DEPARTMENT OF TRANSPORTATION**Federal Aviation Administration****14 CFR Part 39**

[Docket No. FAA–2023–0672; Project Identifier AD–2022–01429–T]

Airworthiness Directives; The Boeing Company Airplanes

ACTION: Notice of proposed rulemaking (NPRM).

Figure 1 to paragraph (g)(2)(i)—*Fundamental Effective Isotropic PSD at Outside Interface of Aircraft Antenna*

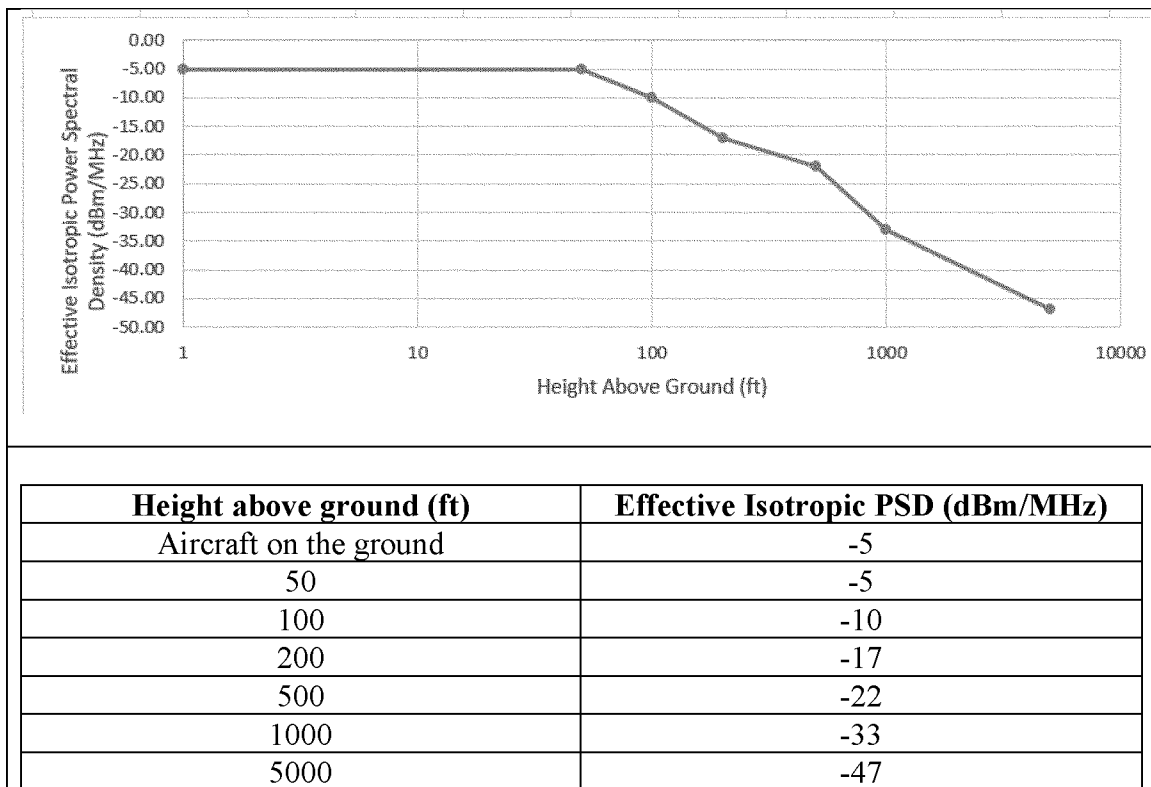
(i) Tolerance to radio altimeter interference, for the fundamental emissions (3.7–3.98 GHz), at or above the power spectral density (PSD) curve threshold specified in figure 1 to paragraph (g)(2)(i) of this AD.

Figure 2 to paragraph (g)(2)(ii)—*Spurious Effective Isotropic PSD at Outside Interface of Aircraft Antenna*

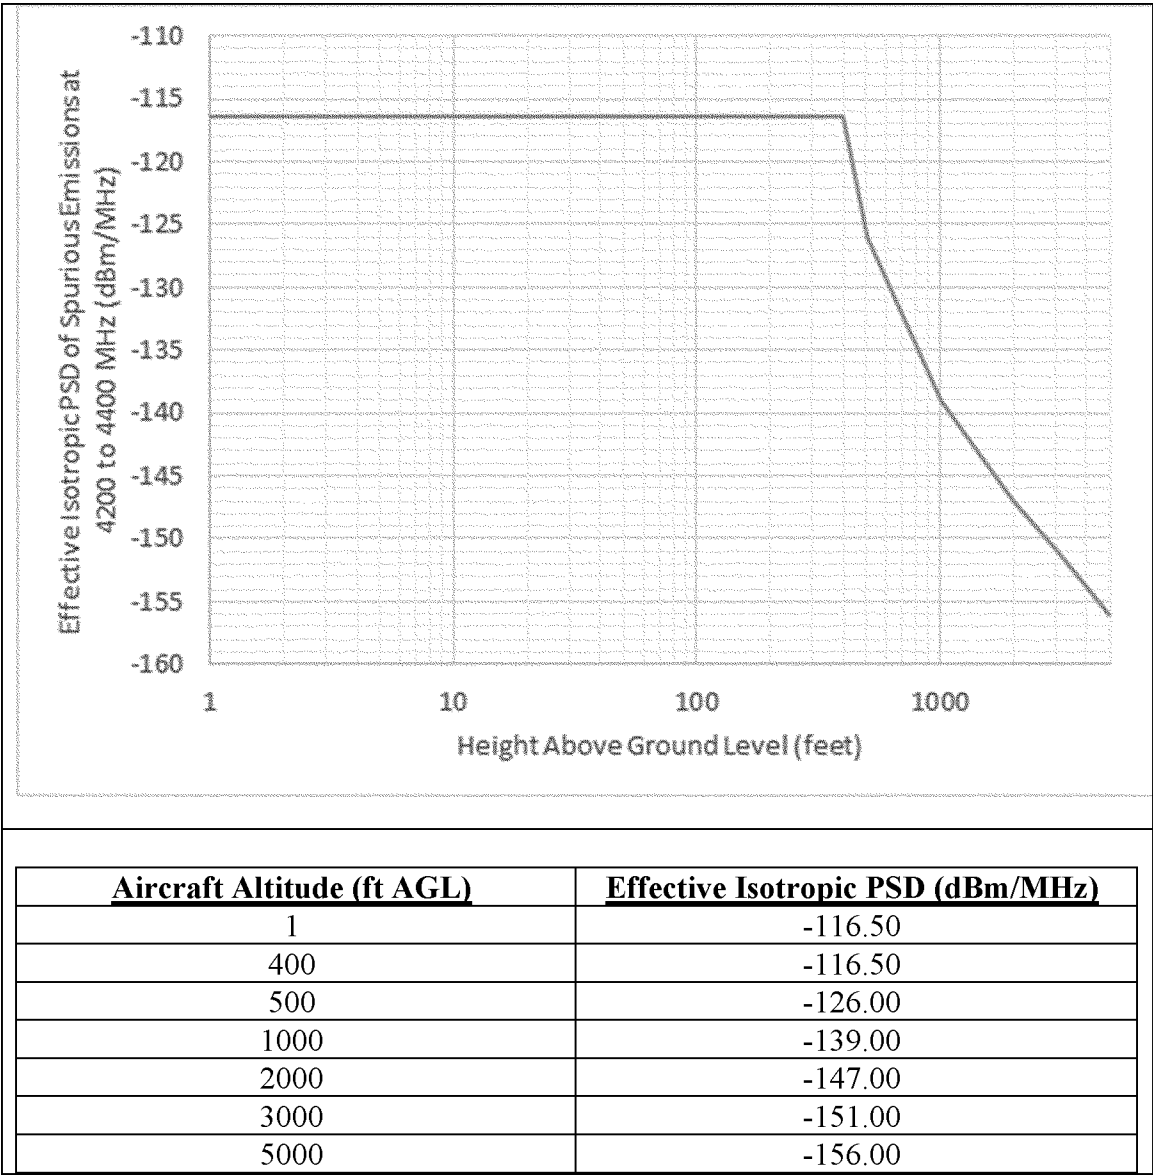
(ii) Tolerance to radio altimeter interference, for the spurious emissions (4.2–4.4 GHz), at or above the PSD curve threshold

specified in figure 2 to paragraph (g)(2)(ii) of this AD.
